MPC Paper No. A/TY/134D
For Consideration by
the Metro Planning Committee
on 16.3.2018

**APPLICATION FOR PERMISSION
UNDER SECTION 16 OF THE TOWN PLANNING ORDINANCE**

APPLICATION NO. A/TY/134

Draft Tsing Yi OZP No. S/TY/27 (in force at the time of submission. The zonings and development restrictions for the site remain unchanged on the current OZP)
- Zoning** : (i) Partly within “Other Specified Uses” (“OU”) annotated “Boatyard and Marine-oriented Industrial Uses” (about 2,173m² or 51% of total site area); and
(ii) Partly outside the OZP Planning Scheme Boundary (about 2,093m² or 49% of total site area)
- Application** : Proposed Temporary Concrete Batching Plant for a Period of 5 Years

參考編號 REFERENCE No. A/TY/134	繪圖 DRAWING A-5
--	-----------------------------

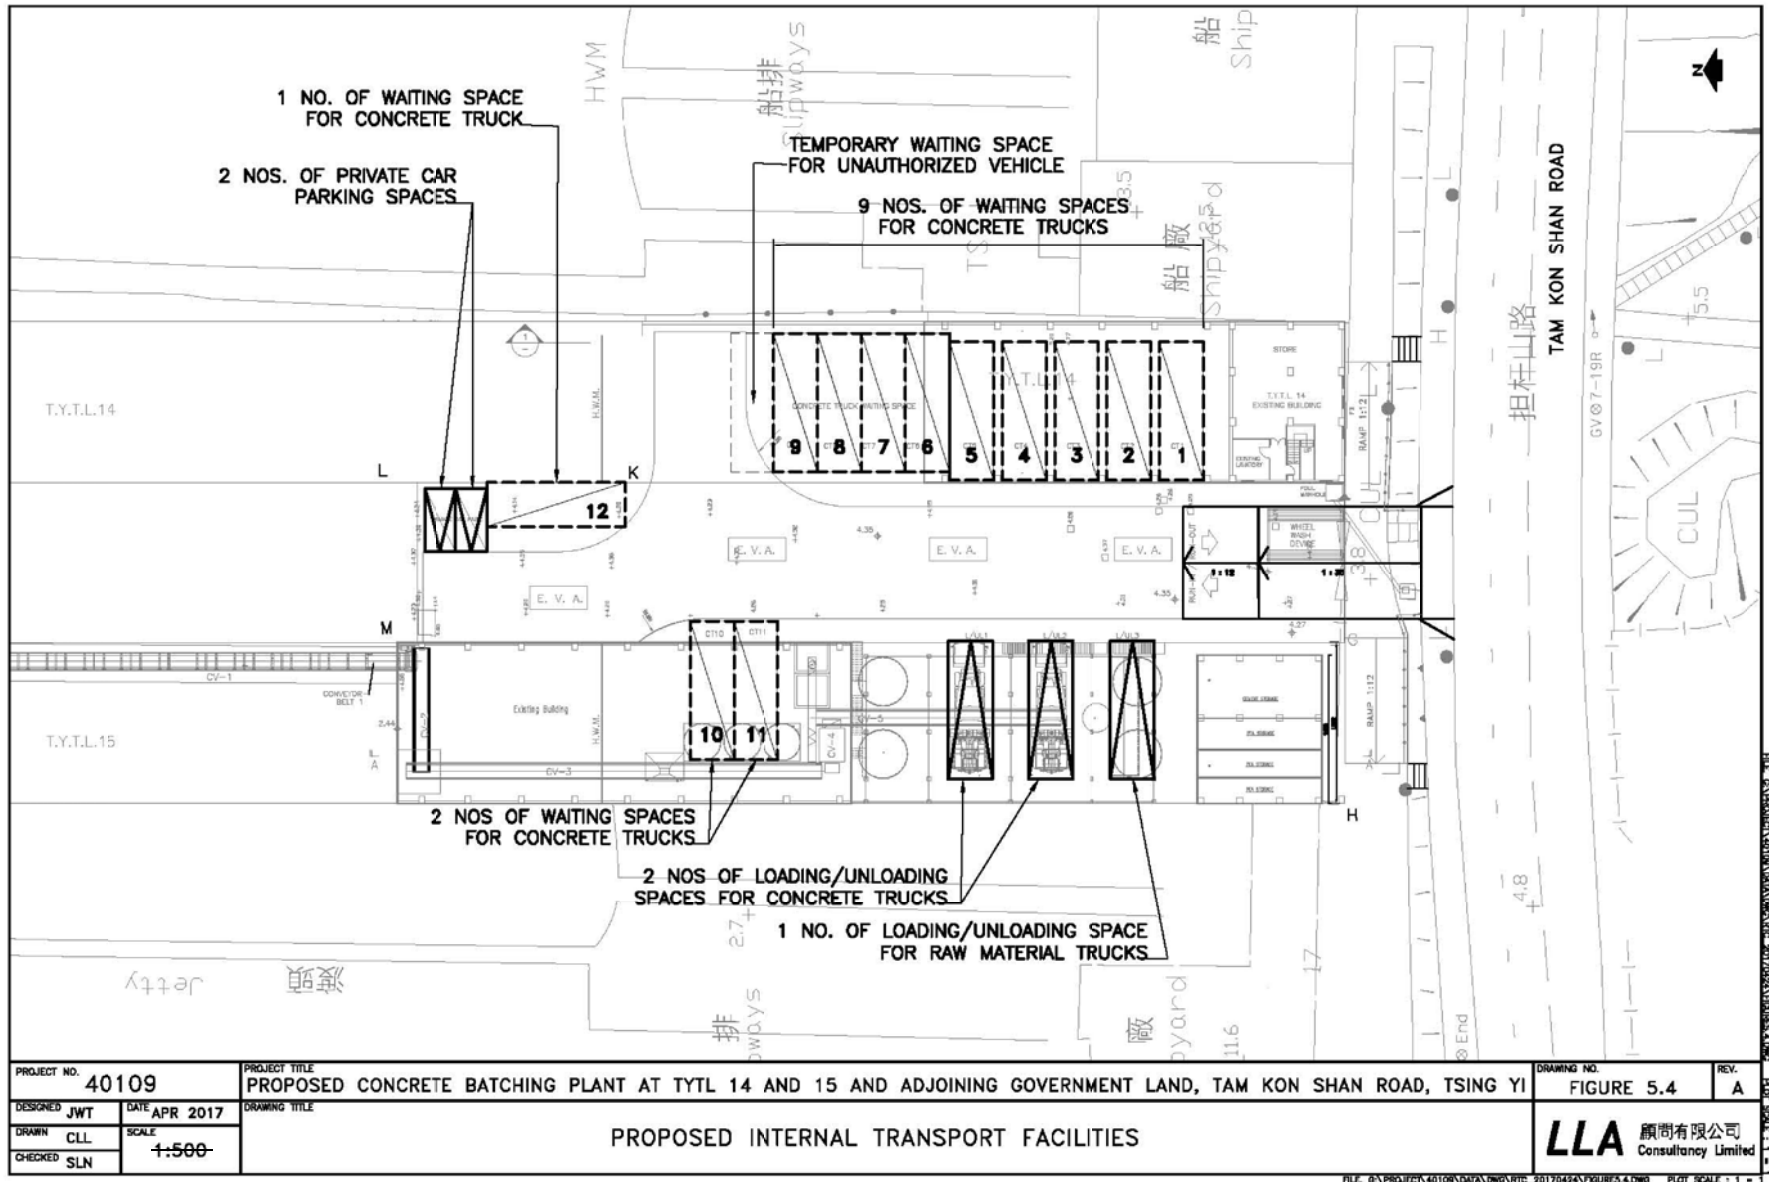
- (a) it is noted that a vehicular access ramp together with 2 pedestrian ramps are proposed and the applicant agrees to undertake the detailed design, construction and maintenance responsibility of the proposed access ramp system from Tam Kon Shan Road to the Site;
- (b) he has no comment on the application from highway maintenance point of view provided that the design, implementation, management and maintenance of the proposed road works including the ramp and run-in/out, etc. proposed by the applicant are to the satisfaction of HyD; and
- (c) should the application be approved, the following condition should be imposed:

繪圖
DRAWING
A-8

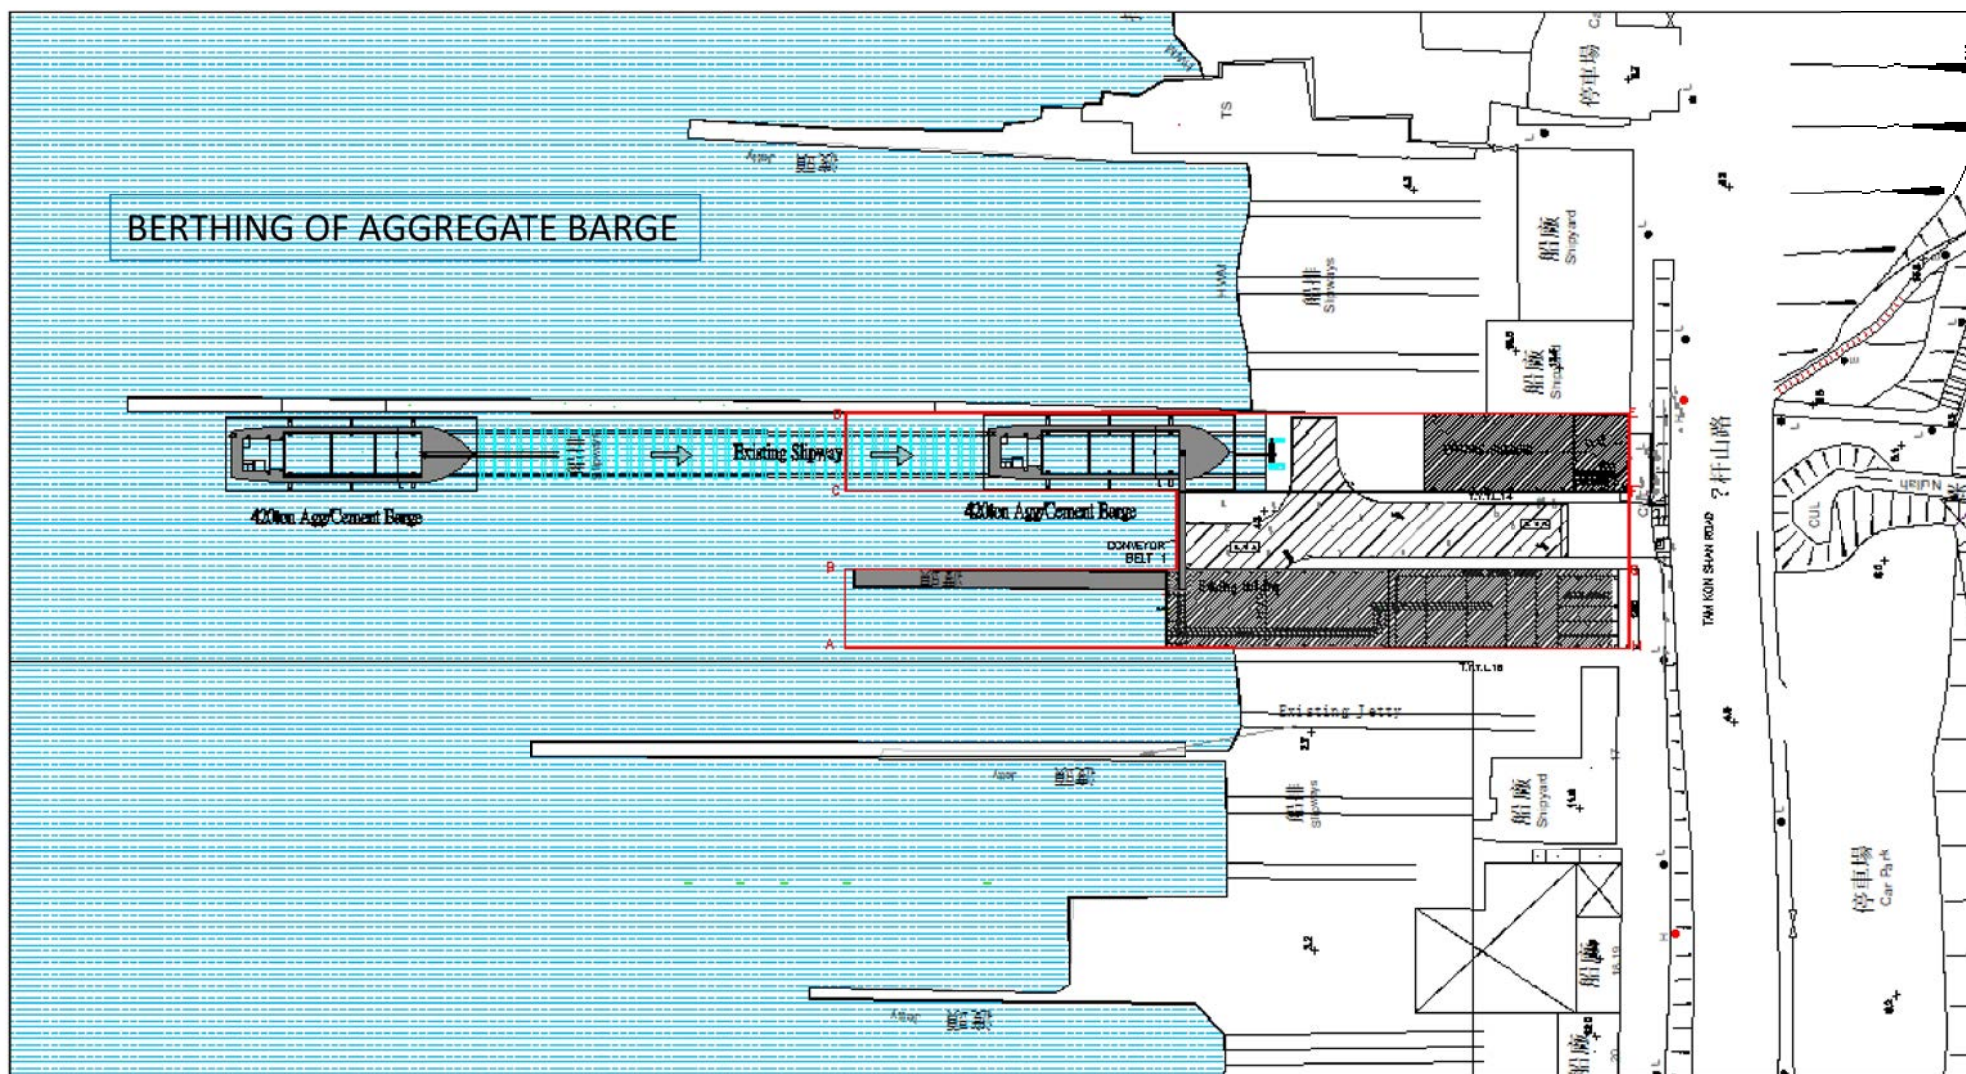
- (c) the slipway falls outside the lot boundary and hence it is not acceptable from the lease (**Appendix Is** and **Drawing A-8**);
- (d) if the planning application is approved by the Board, the lot owner/tenant should apply to the LandsD for a temporary waiver for the amendment of the user in respect of TYTL Nos. 14 and 15 and a modification of STT 538 K&T for the amendment of the user subject to paragraph 8.1.1 (b) above and the addition of the vehicular access via the Government land (as a non-exclusive right of way to the tenancy area) subject to the comments of DSD and the agreement of TD and the Highways Department (HyD). The application will be considered by the LandsD acting in the capacity as landlord at its sole discretion. There is no guarantee that any such application will be approved by the Government. Any approval if given will be subject to such terms and conditions including, inter alia, payment of waiver fee/rental and administration fee as may be approved by the Government; and

參考編號 REFERENCE No. A/TY/134	繪圖 DRAWING A-10
--	------------------------------

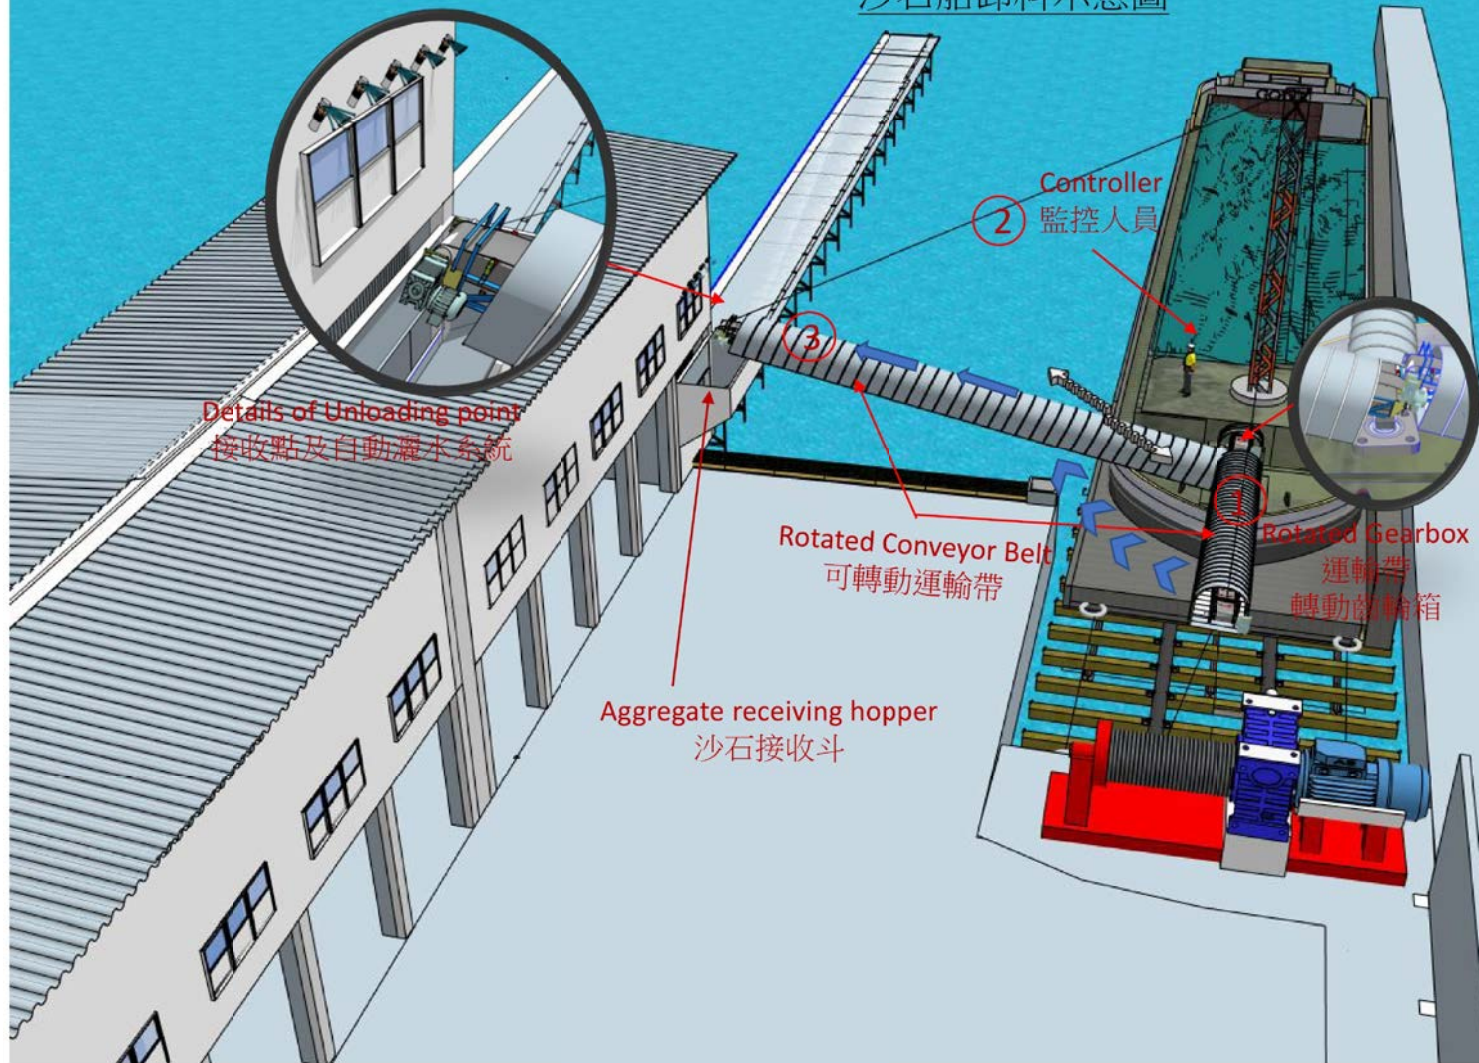
- (iv) with reference to the “Aggregate Unloading Procedure” in Appendix H of **Appendix Iq**, the applicant has briefly described and illustrated the built-in conveyor belt of the aggregate barge would be rotated at right angle to the barge for discharging aggregate. The applicant has been requested to provide information about the safety measure of such operation. Although the applicant responded that this requirement can be imposed as an approval condition, the applicant has yet to provide information about the safety measures to be adopted and implemented for the proposed unloading arrangements so that it can be carried out safely without causing the listing of the barge as the raw materials inside the barge may not be evenly distributed and liable to shifting during the unloading process;
